Letter of Response

**RE: Response to Comments Letter
117 Main Street
Medway, MA 02053
Bohler Project #MAA240482.00**

On behalf of the applicant, Route 85 Realty Corp., please allow this letter to serve as our formal response to your letter dated May 13, 2026 regarding the Heritage on Main Street Application, prepared by the Town of Medway – Community and Economic Development Department for the above mentioned project. For your reference, the comments provided by Medway's Planning and Economic Development Board ('PEDB') are shown in standard font type and the applicant team's responses are shown in bold font type. Three figures as noted in the responses are enclosed as a part of the responses for reference.

OUTDOOR AMENITY AREA EXHIBIT
5/20/2026

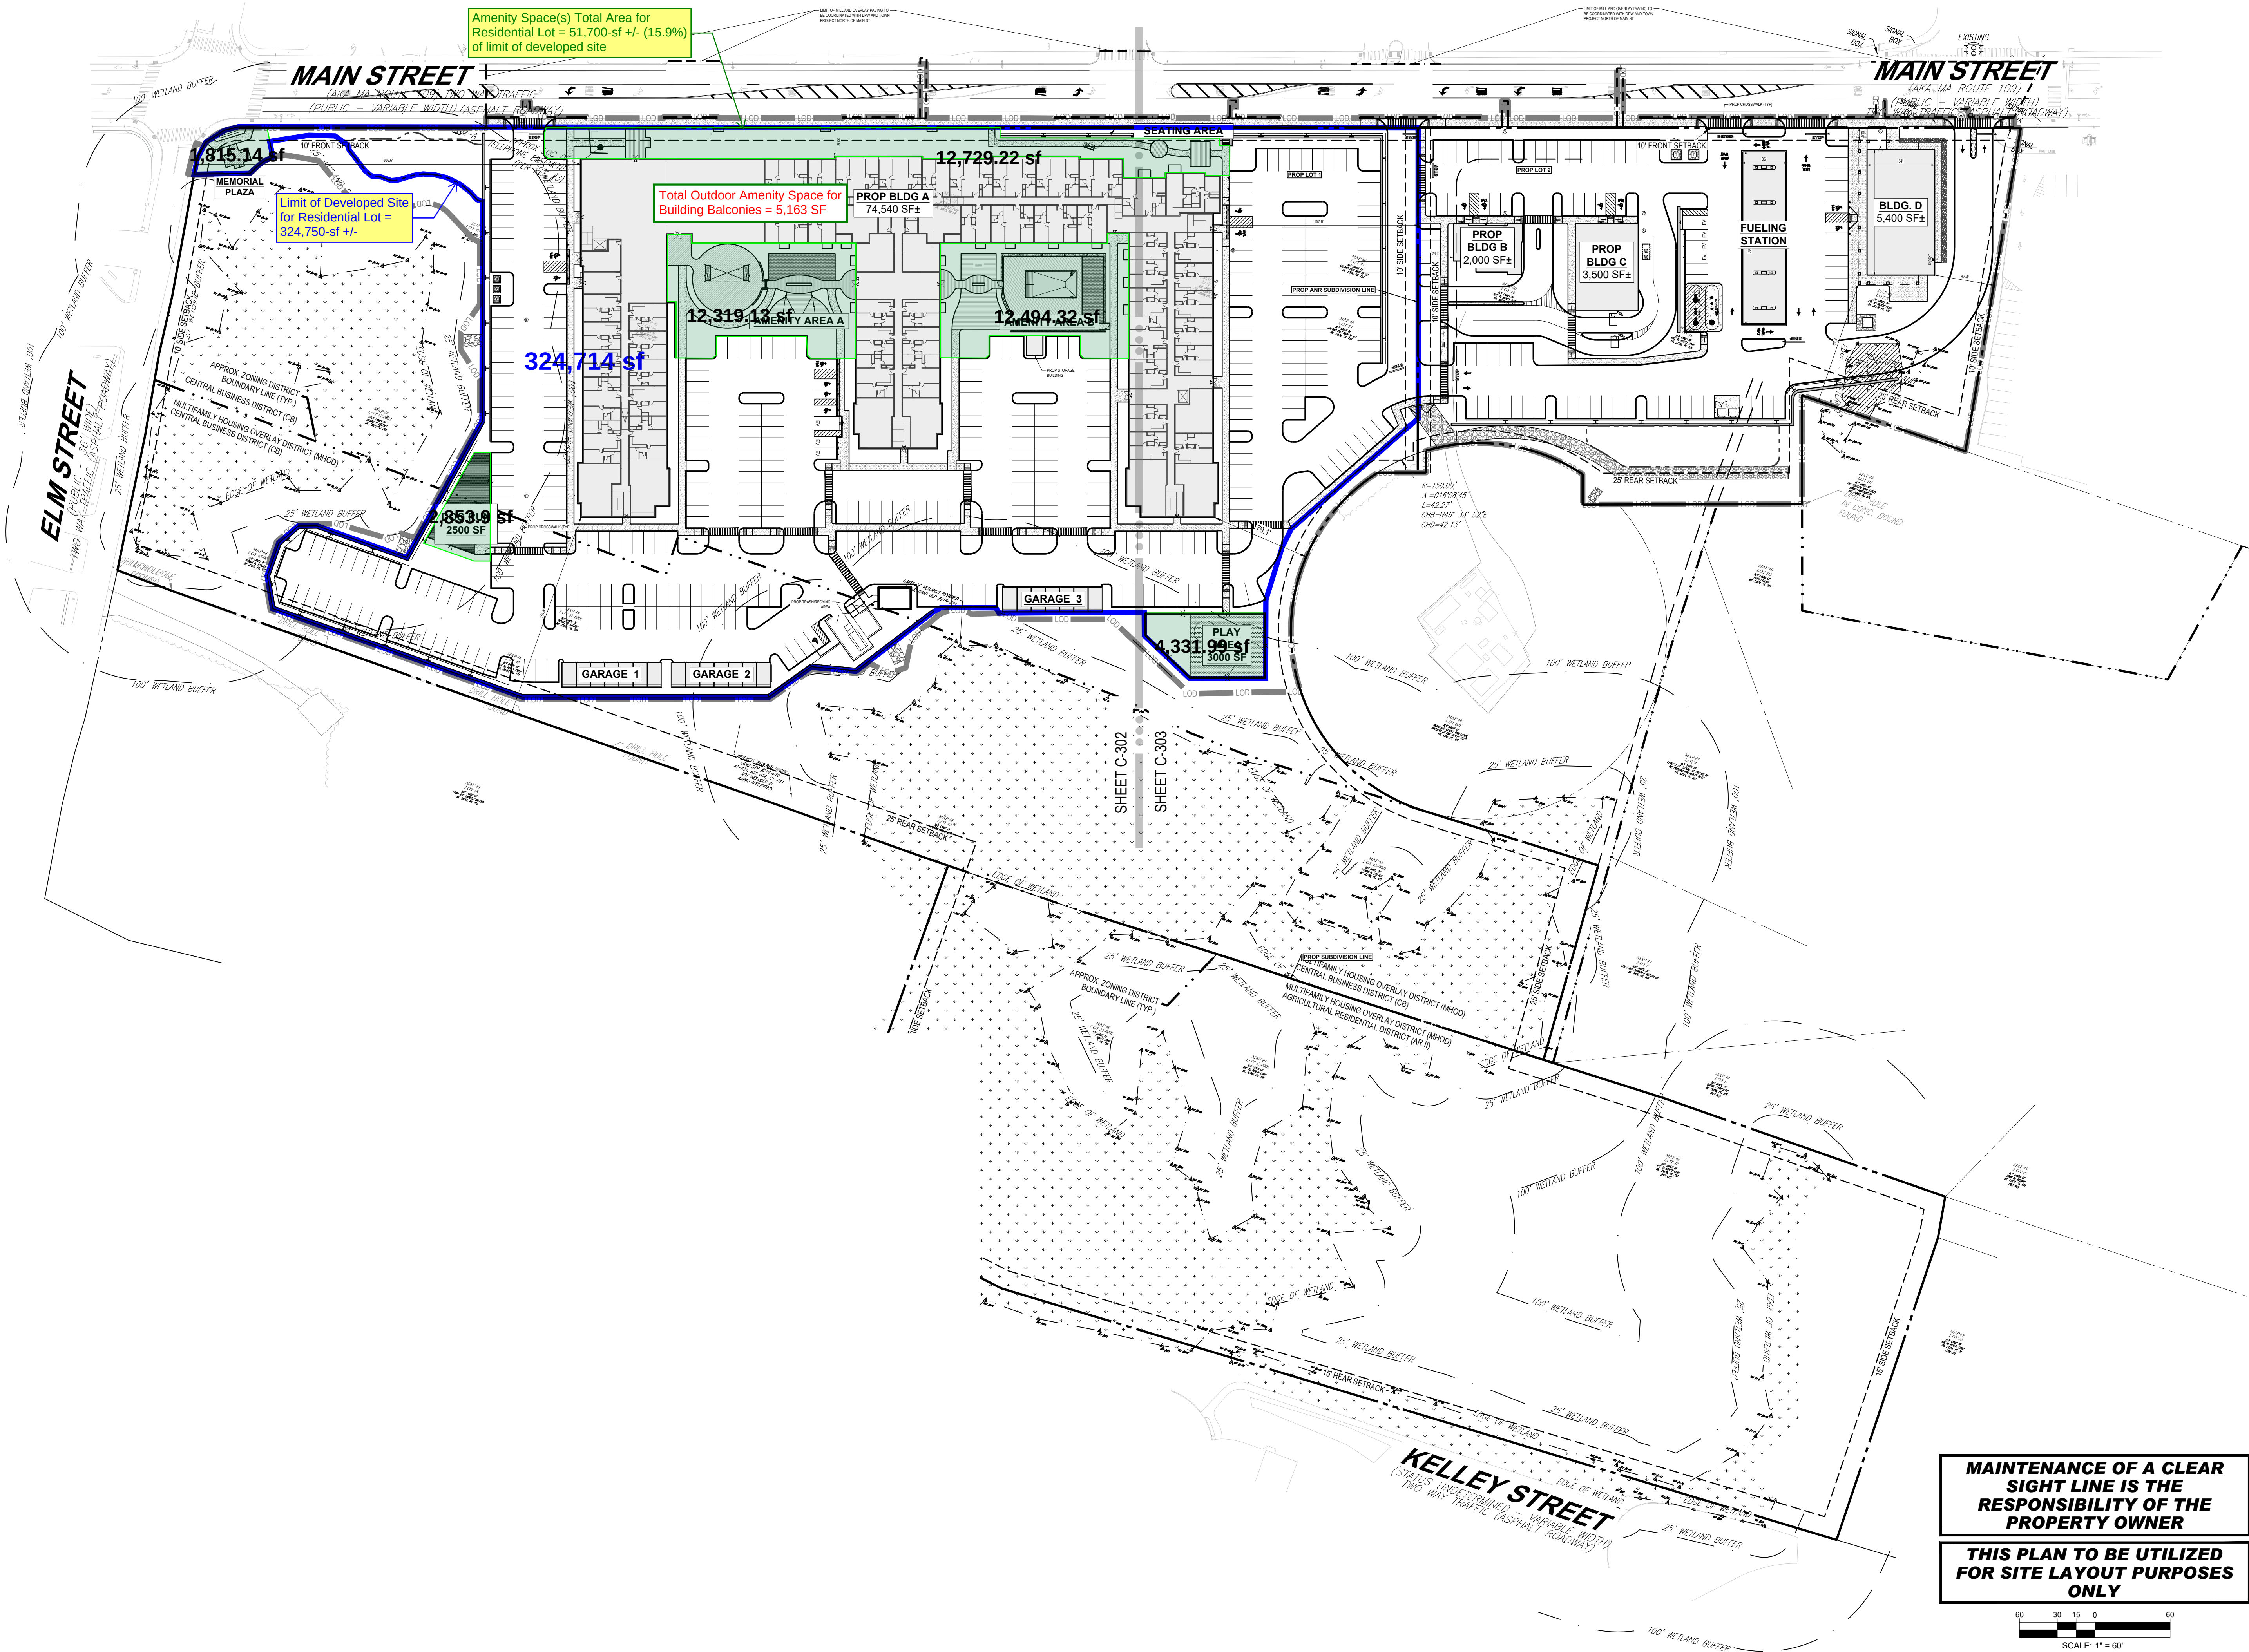
8. Amenity spaces: Under Section 10.2.F, at least 15% of the lot or development site shall be dedicated to Outdoor Amenity Space. The applicant needs to demonstrate compliance with this requirement, as there does not appear to be any calculation provided as to the percentage of Outdoor Amenity Space. Section 10.2.F lists specific types of Outdoor Amenities that qualify toward the 15%. In addition, the applicant has applied for a special permit under Section 10.2.F.4, which allows the Board to allow other types of Outdoor Amenities by special permit.

The project intends to comply with the 15% amenity space requirement for the “development site” as defined as limit of disturbance on Lot 1 (the Residential lot). A Outdoor Amenity Space exhibit, showing the approximate breakdown of outdoor amenity spaces on the “development site”, is enclosed for the Board’s reference.

Amenity Space(s) Total Area for Residential Lot = 51,700-sf +/- (15.9%) of limit of developed site

Limit of Developed Site for Residential Lot = 324,750-sf +/-

Total Outdoor Amenity Space for Building Balconies = 5,163 SF
